**Renault-Opel-Vauxhall-Nissan
Tie Rod End**

Sidem Nr	OE Number
6534	48520 00QAK
6535	48520 00QAL

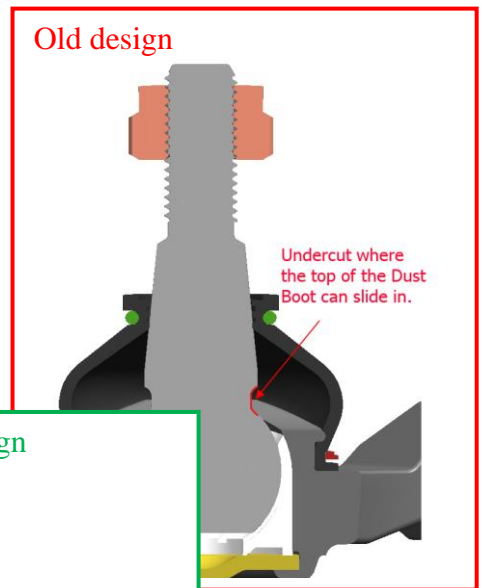
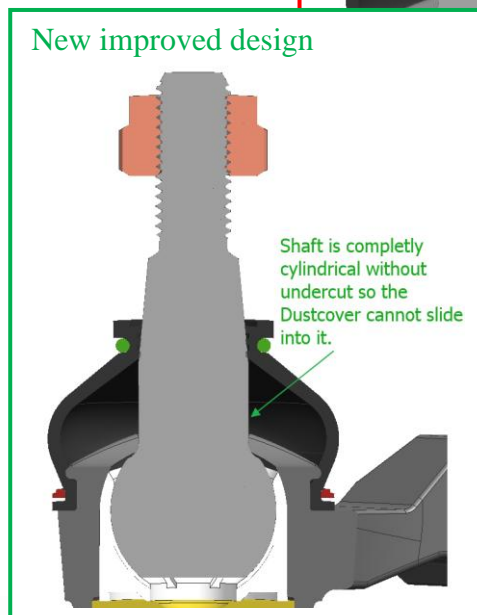
Problem:

- Possibility of shooting the top of the DC in the neck while installing the Tie Rod End

Cause:

- Neck on ballpin without mechanical seat

Solution:

- The neck on the ballpin is removed on The ballpin, so no possibility anymore for the DC to shoot in the neck
